**NOTICE OF DECISION**  
 USNR – Site Plan and Building Expansion

<b>Land Use Application Nos.:</b>	SPR 21-006 (Site Plan Review – Type 1)
<b>Applicant:</b>	Daniel Snair 1001 SE Water Avenue #261 Portland, OR 97214
<b>Property Owner:</b>	USNR LLC PO Box 310 Woodland, WA 98674
<b>Site Location:</b>	1981 Schurman Way Woodland, WA 98674
<b>Parcel &amp; Size:</b>	507880100, 7.49
<b>Zoning Designation:</b>	Light Industrial, I-1
<b>Date Application Received:</b>	May 27, 2021
<b>Notice of Application &amp; Likely DNS issued:</b>	N/A
<b>Comment Period &amp; SEPA Appeal Period Ended:</b>	N/A
<b>Notice of Decision Issued:</b>	July 9, 2021
<b>DRC Decision:</b>	Approve with Conditions

Tenant improvements are planned for the existing building including interior renovation, addition of 650 sq. ft. to the south side of the building, parking expansion of 2,800 sq. ft. and construction of a 2,600 sq. ft. patio.

**G0.3.0**  
 SITE PLAN

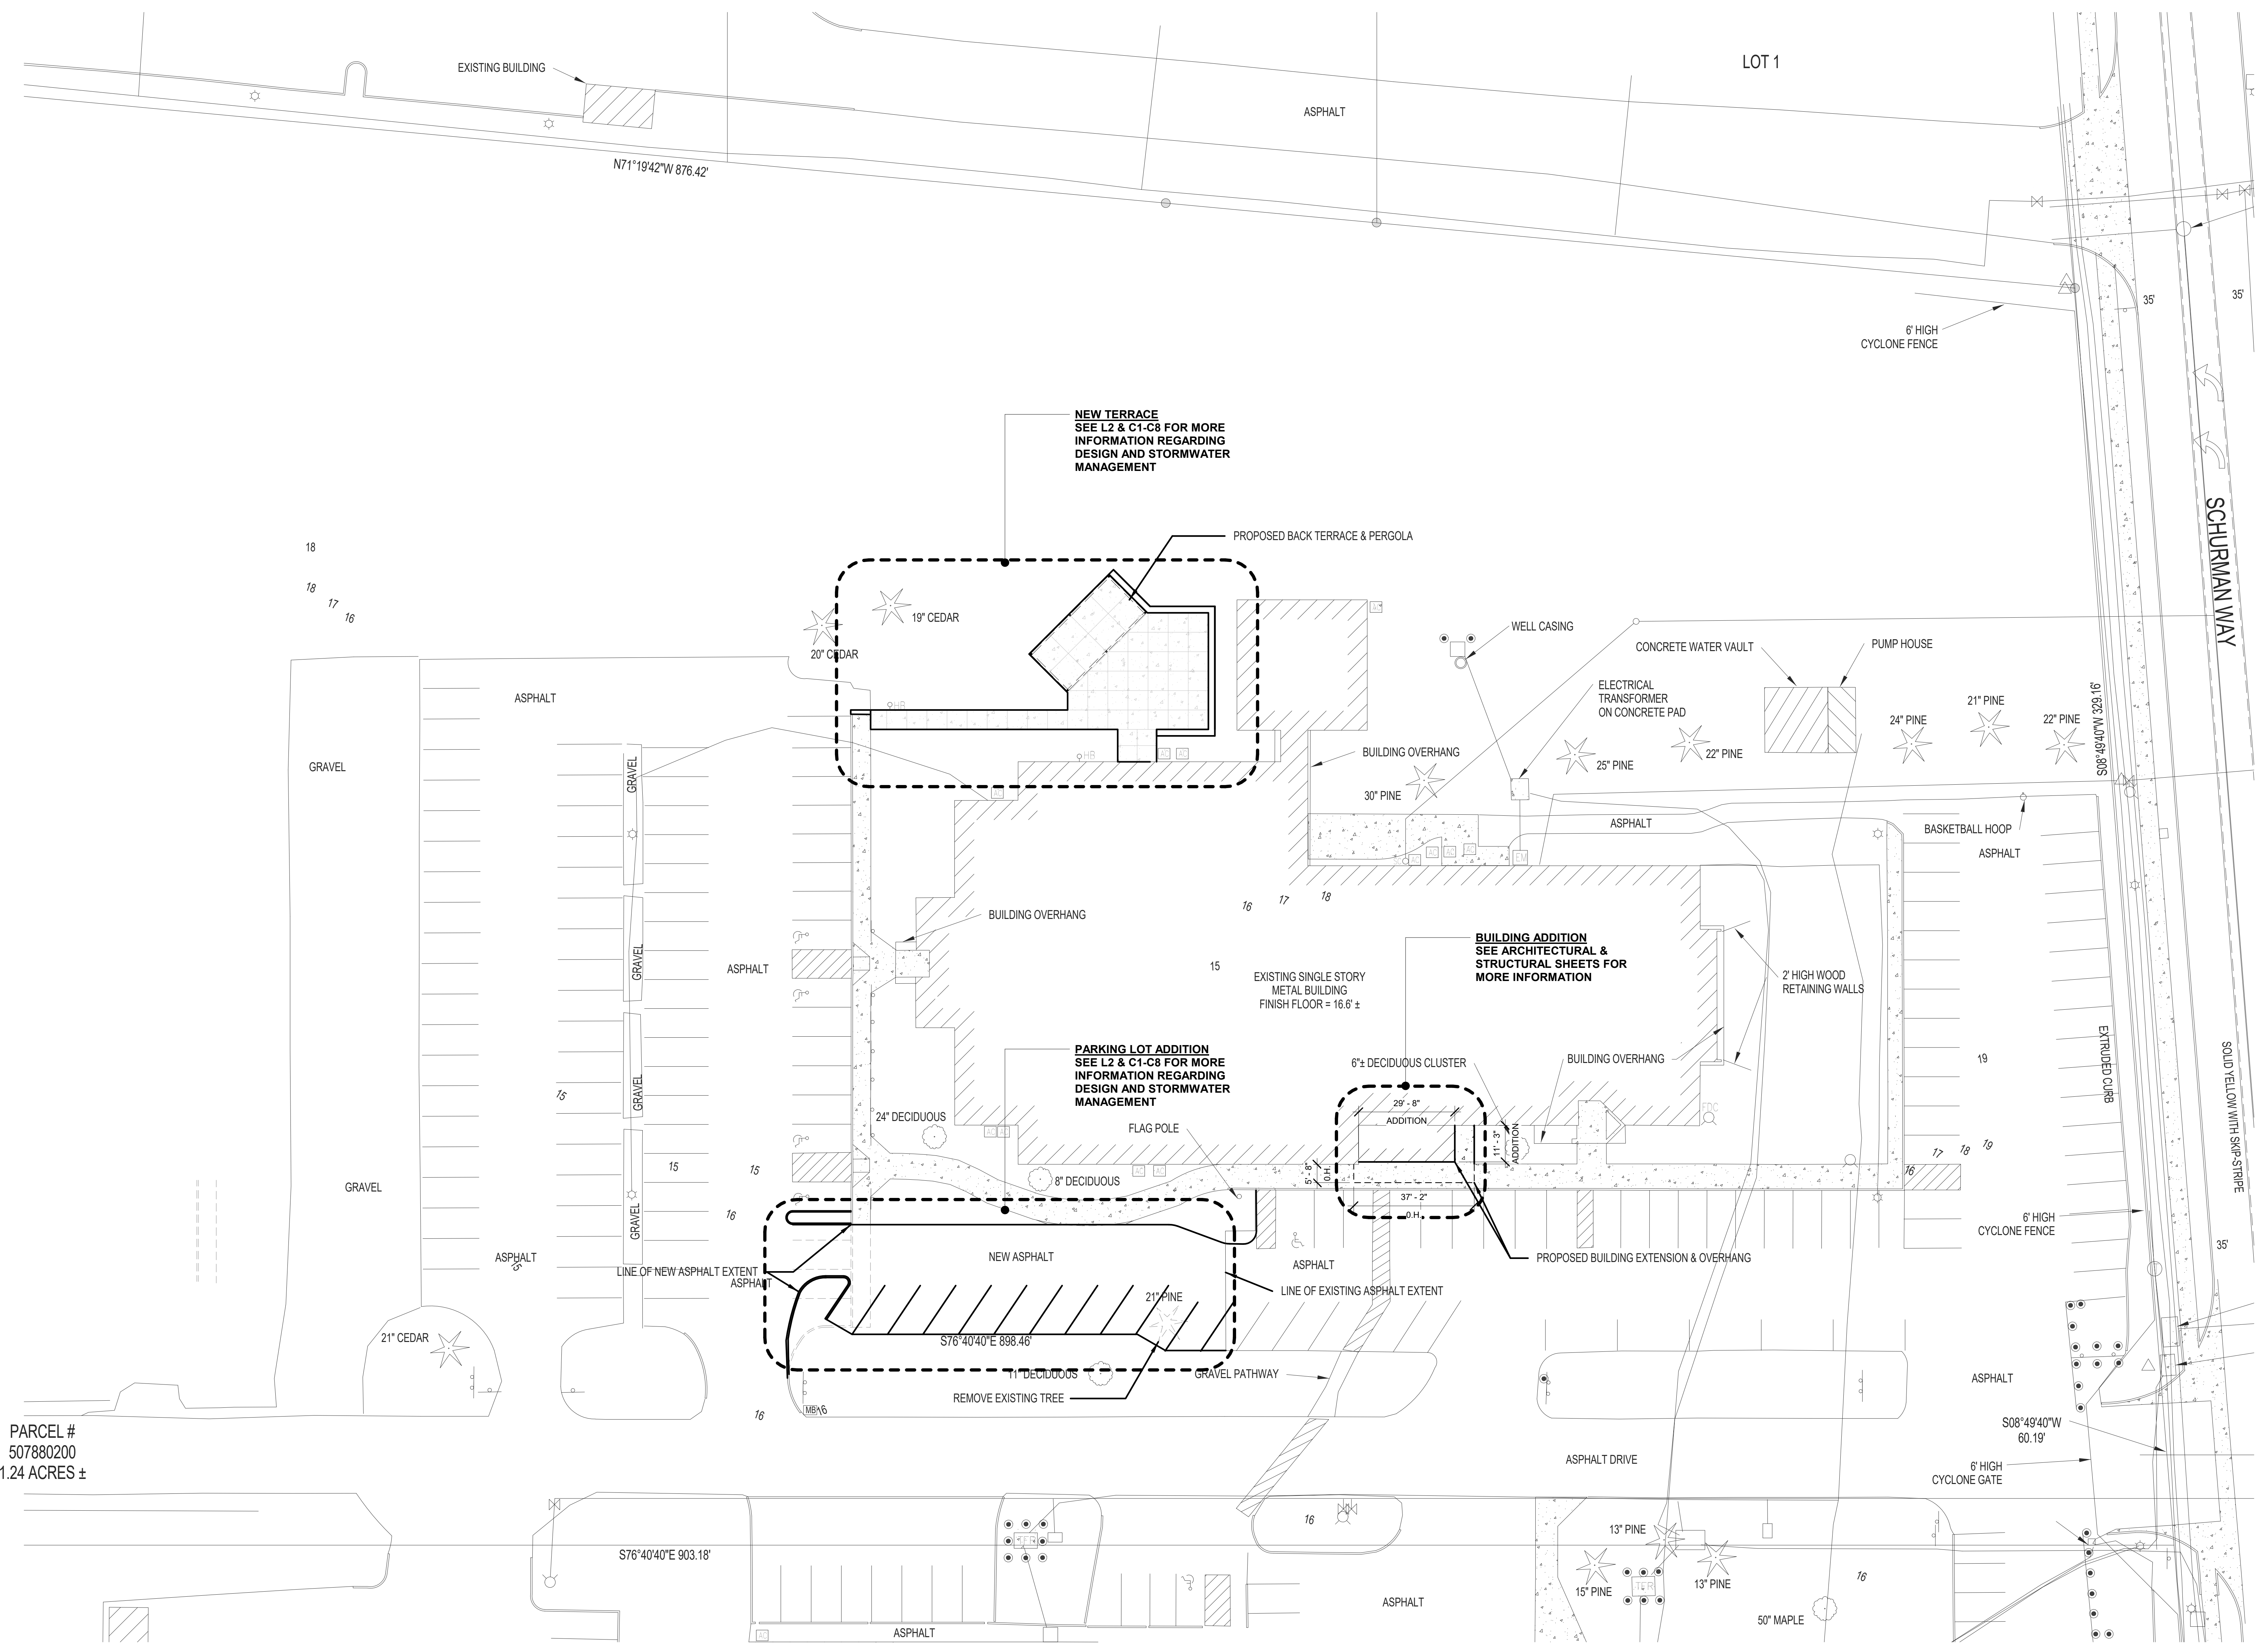
**Finding 46:** Approved access road shall be a minimum clear width of 20' (26' where a hydrant is located). CCFR finds that location marked on CCFR's review is less than 20 ft. in width. Fire Apparatus Access roads shall be at a minimum 20 ft. in width. A condition is added to revise the site plan to meet the minimum access road width and resubmit to the City and CCFR. *See Condition #22.*

**Finding 48:** Hydrants must be provided on fire access roadways so that average spacing does not exceed 500 ft. (400 ft. for Dead-end roads) and the maximum distance from any point on the street frontage to a hydrant is no more than 250 ft. (200 ft. for dead-end roads). A condition is added to revise the site plan to indicate location of fire hydrants in accordance to fire code. *See Condition #24.*

**Finding 49:** Per IFC C102, hydrants shall be installed with a 5" Storz connection adapter. Additionally, a Storz connection adapter must be installed on the hydrant east of the office at the main entrance. A condition is added to add a note to the site plan that hydrants will be installed with 5" Storz connections. *See Condition #25.*

**Finding 51:** Turning radius for fire apparatus access roads shall be a minimum of 28 ft. or greater. The outside turning radius for access roads shall be 48 ft. or greater. A condition is added to meet CCFR turning radius requirements. *See Condition #27.*

**Finding 52:** "NO PARKING – FIRE LANE" shall be signed or marked at locations designated on the plan reviewed by CCFR. A condition is added to indicate No Parking/Fire Lane areas on the site plan. *See Condition #28.*

**Finding 53:** Locations at the NE and NW of the parking lots shall be kept free at all times for emergency response access as indicated on the plans reviewed by CCFR. A condition is added to include a note on the site plan to keep the NE and NW parking lots clear at all times for emergency response access. *See Condition #29.*

22. Approved access road shall be a minimum clear width of 20' (26' where a hydrant is located). CCFR finds that location marked on CCFR's review is less than 20 ft. in width. Fire Apparatus Access roads shall be at a minimum 20 ft. in width. Revise the site plan to meet the minimum access road width and resubmit to the City and CCFR.

24. Revise the site plan to indicate location of fire hydrants in accordance to fire code.
25. Add a note to the site plan that hydrants will be installed with 5" Storz connections.

26. Include a note on the site plan that hydrants shall remain accessible during construction
27. Turning radius for fire apparatus access roads shall be a minimum of 28 ft. or greater. The outside turning radius for access roads shall be 48 ft. or greater. Revise the site plan to meet CCFR turning radius requirements.

28. Indicate "NO PARKING – FIRE LANE" on the site plan as instructed by CCFR.
29. Locations at the NE and NW of the parking lots shall be kept free at all times for emergency response access as indicated on the plans reviewed by CCFR. Include a note on the site plan to keep the NE and NW parking lots clear at all times for emergency response access.

**PLANTING NOTES**

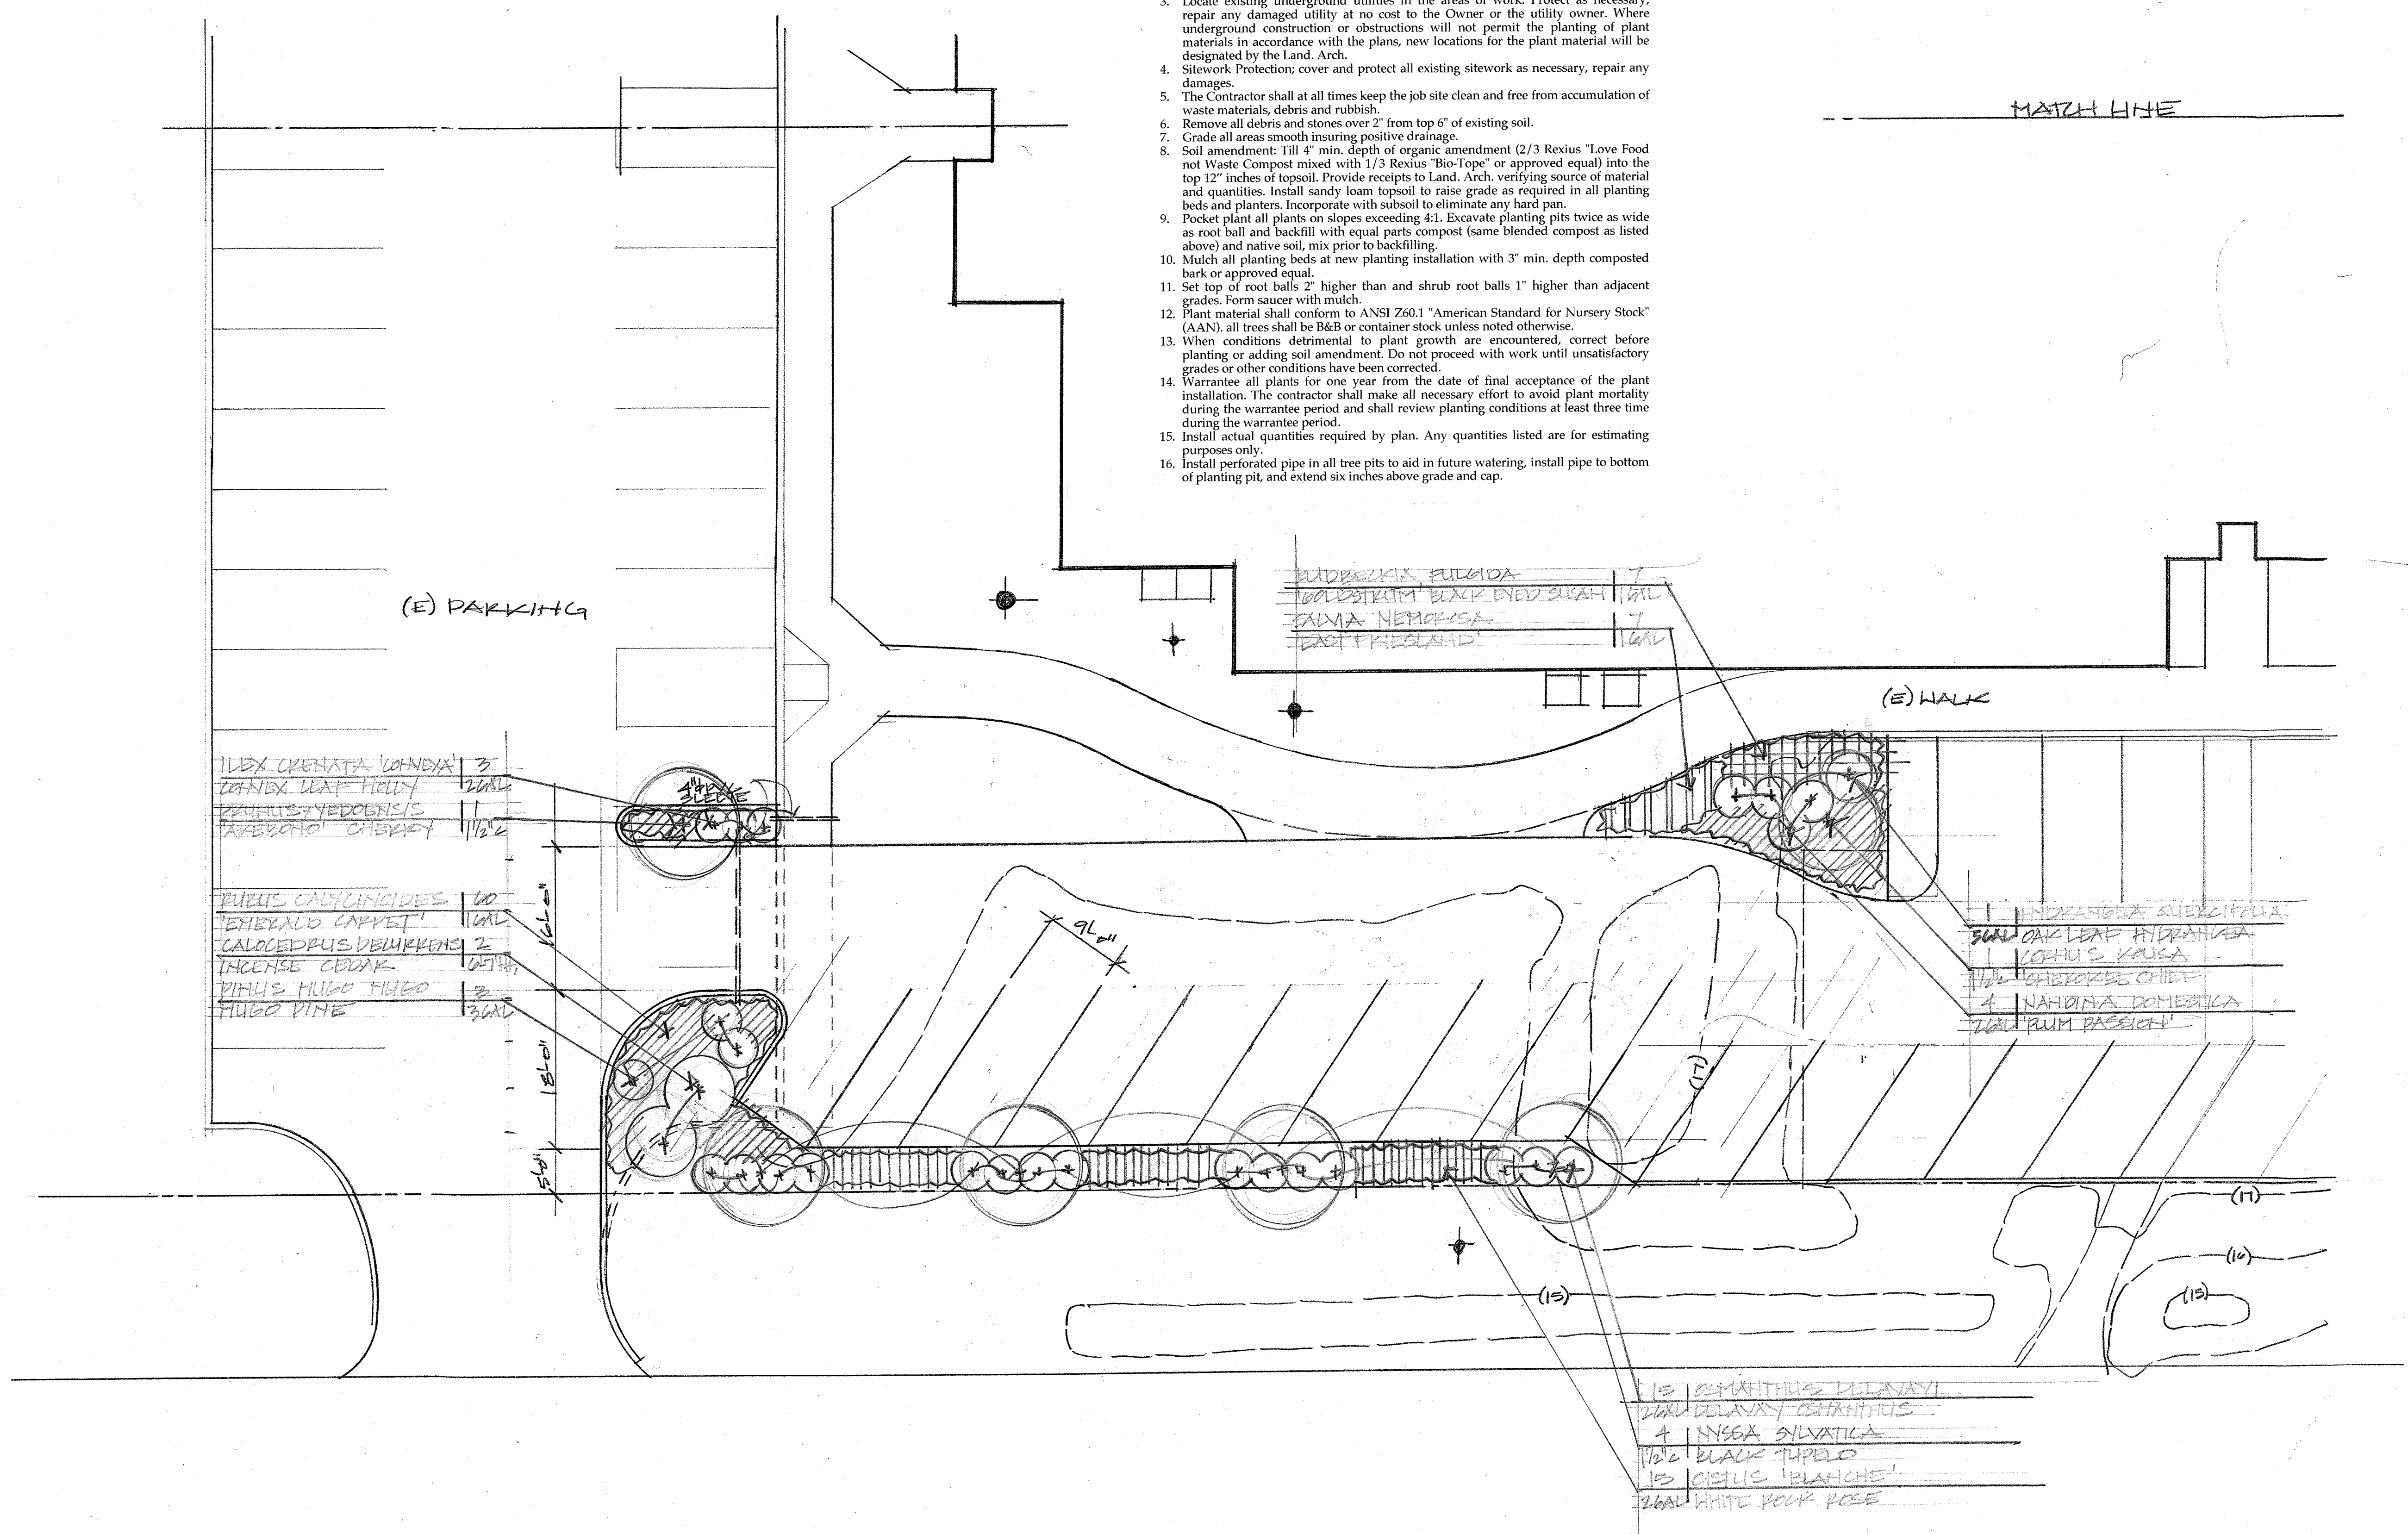
**Finding 19:** The landscaping plan set does not include the required calculations. A condition is added to include these calculations on Plan Set L and resubmit. *See Condition #9.*

**Finding 20:** Ten percent of the entire site must be landscaped per WMC 17.44.135. A condition is added to show that 10% of the site is landscaped on the landscaping plan. *See Condition #10.*

**Finding 24:** Not all trees indicated on the landscaping plan meet the size requirement. Revise the landscaping site plan to indicate that the size of trees to be planted is 2-inch caliper or more. *See Condition #11.*

**Finding 26:** Not all shrubs are indicated to be 5-gallons or larger. A condition is added to include the size of the shrubs (at least 5-gallon) on the landscaping plan. *See Condition #12.*

**Finding 28:** A plant survival guarantee was not included on the landscaping plan. A condition is added to include a guarantee on the site plan stating that the owner will replace plantings that fail to survive. *See Condition #13.*

**Finding 35:** A total of 30 trees (approximately) is required by WMC 17.44.136 (F)(2). A condition is added to revise the site plan showing calculations for the parking area, parking landscaping and number of parking spaces and number of trees. *See Conditions #9 and #14.*

**Finding 37:** The parking lot along Schurman Way is not landscaped with an evergreen hedge or wall. If the parking is within the 25-ft. front setback, an evergreen hedge or wall is required. A condition is added to update the site plan to show that the parking is outside the 25-ft. front setback or update the landscaping plan with an opaque

9. Revise the landscaping plan to show area and percentage for:
  - a. Entire site;
  - b. Total landscaping areas;
  - c. Areas covered by groundcover;
  - d. Areas covered by nonplant materials;
  - e. Areas covered by tree canopy and shrubs;
  - f. Each required setback area;
  - g. Total parking area;
  - h. Parking landscaping; and
  - i. Other landscaping areas.

10. Revise the landscaping plan to show that 10% of the site is landscaped per WMC 17.44.135.
11. Revise the landscaping site plan to indicate that the size of trees to be planted is 2-inch caliper or more.

12. Revise the landscaping site plan to indicate that the size of shrubs to be planted is 5-gallons or more.
13. Add a note to the landscaping plan that the owner is required to replace plantings that fail to survive.

14. Calculate the number of trees and parking spaces on the landscaping plan for all parking areas and show how WMC 17.44.136 (F)(2) is met. Trees proposed in the new parking area may count toward the total requirement.

15. Update the site plan to show that the parking is outside the 25-ft. front setback or update the landscaping plan with an opaque structure or planting that meets the requirement of WMC 17.44.136 (F)(3).
